From: Bruce Sounes <bruce@studioe.co.uk>
Sent: 23 September 2013 14:27
To: Terry Ashton
Cc: Grenfell; M.Smith@maxfordham.com
Subject: RE: Grenfell Tower
Attachments: Stair Placement.jpg

Subject: RE: Grenfell Tower

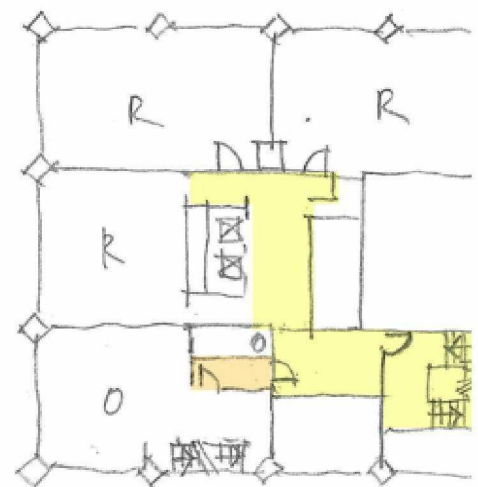
For the EMB offices, If we keep exits at Mezzanine and Walkway – suitably lobbied – could we treat the new stair as an accommodation stair? Eg:

- no doors/fire rated enclosure?
- A “private” stair under Part K? 1200 width, 280mm going, 200 risers?
- Winders at top or bottom?
- No restriction on the placement of the accommodation stair, or need to escape directly to outside.
- Could it be part of the lobby itself?

This would allow us to minimize the area occupied by the stair.

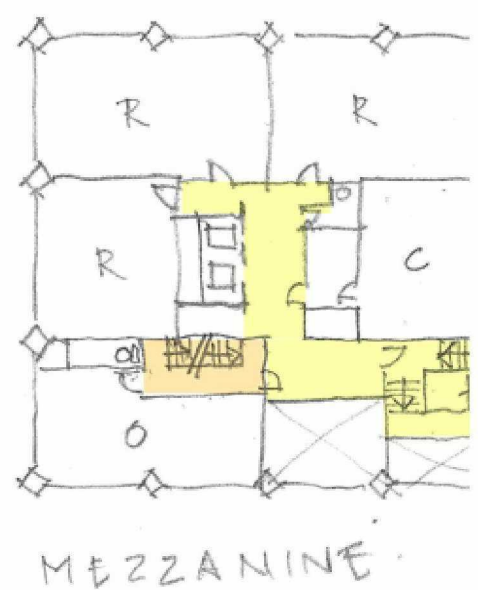
Please could I get your thoughts on these 2 options? (yellow – main escape. Orange – vented lobby)

Option 1 – Reduced stair footprint. Lobby missing on ground floor, but this could be accommodated.

Option 2 – Stair moved inboard to make better use of space. Whole stair is vented lobby.

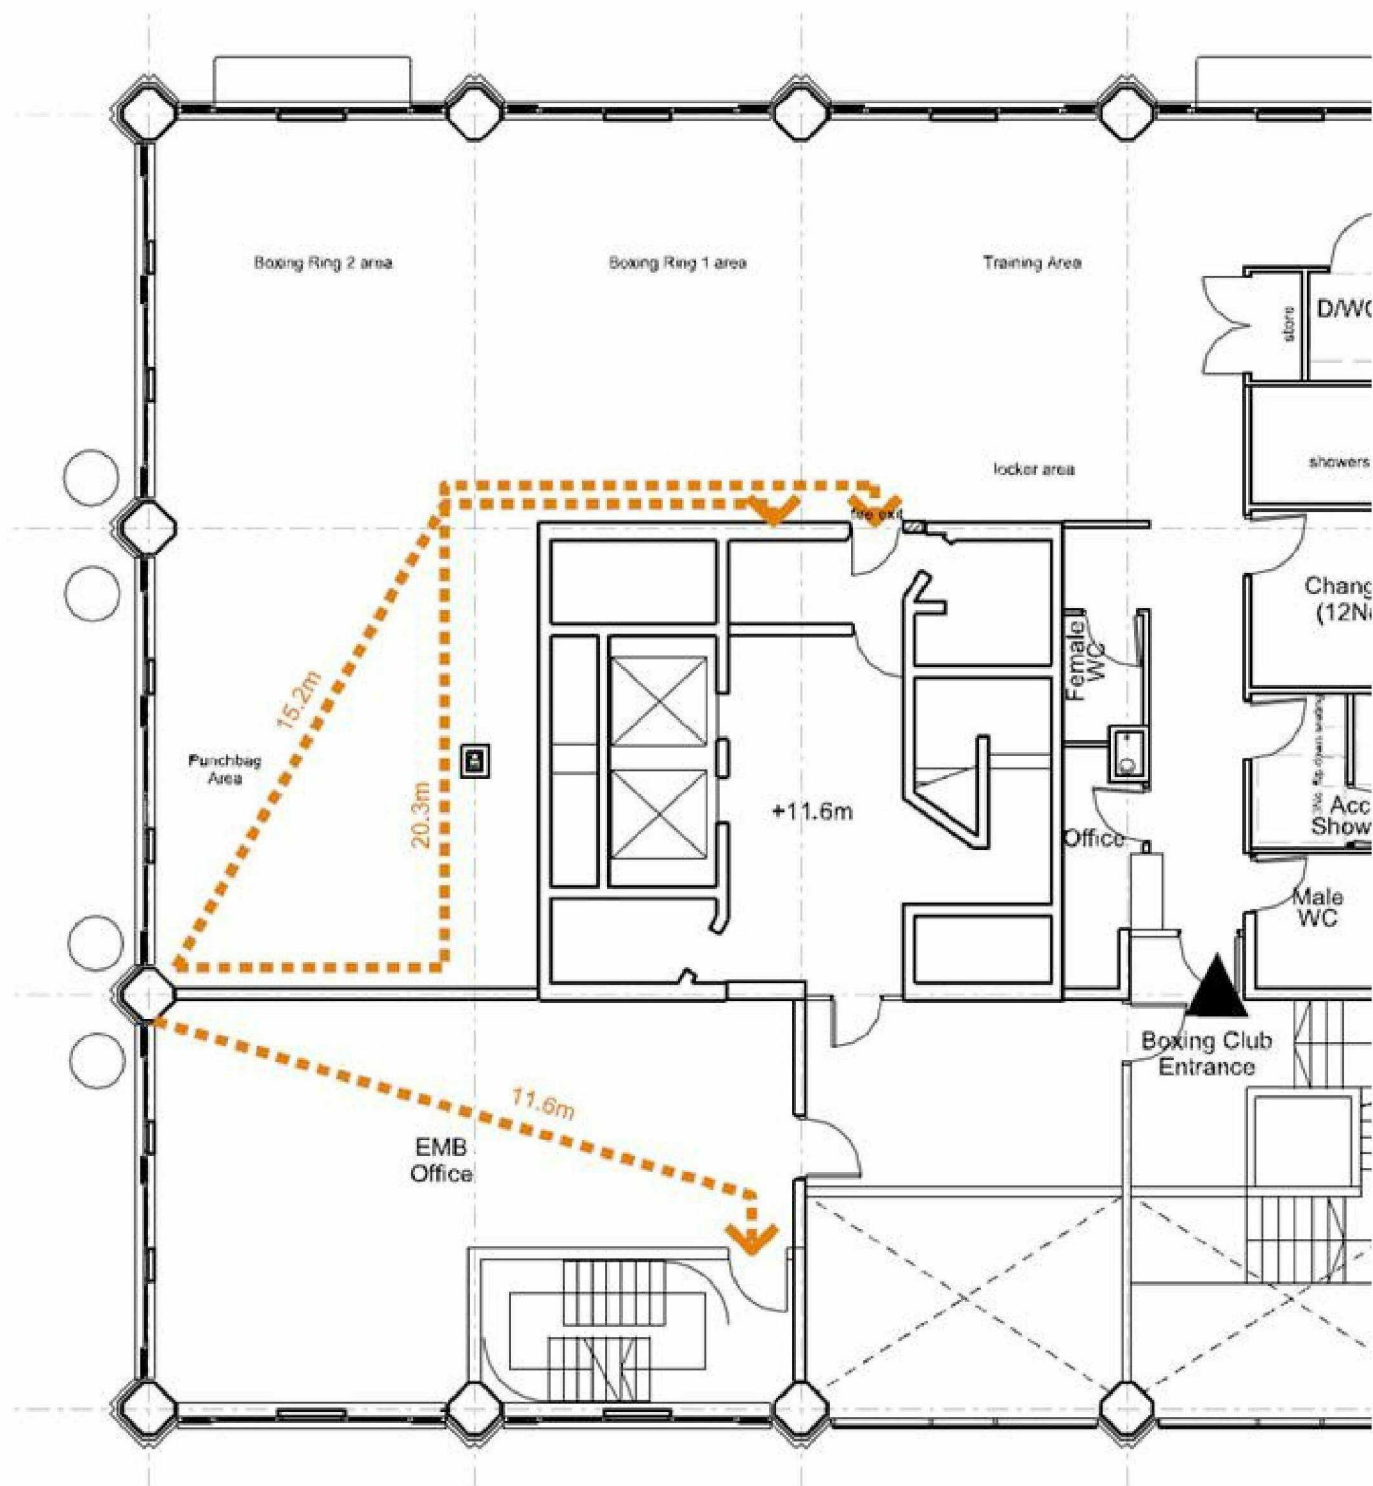
Thank you for the markups which are very useful. It will take a few days to digest and we are still juggling with service risers and structural solutions so the layout could be fluid and we may be able to accommodate the lobbies more satisfactorily than they are shown.

1. My initial take of the travel distances are we are okay. Do you agree?

2. The connection between office and stair is possibly optional. If the TMO agree it could be kept as a 2hr compartment wall with no door/lobby. Would a single stair be adequate?

The dead end direct distance to the nearest exit from the punchbag area of the boxing club is more than the 12m permitted in Approved Document B but within (just) the 15.5m implied in BS 9999 for an occupancy with a B1 risk profile (2/3 of 24m) so I think that we could persuade RBKC to accept the design. With regard to the EMB offices, provided the stair is approached via protected lobbies at ground and mezzanine levels, there would be no need for it to be connected to the escape route from the main tower.
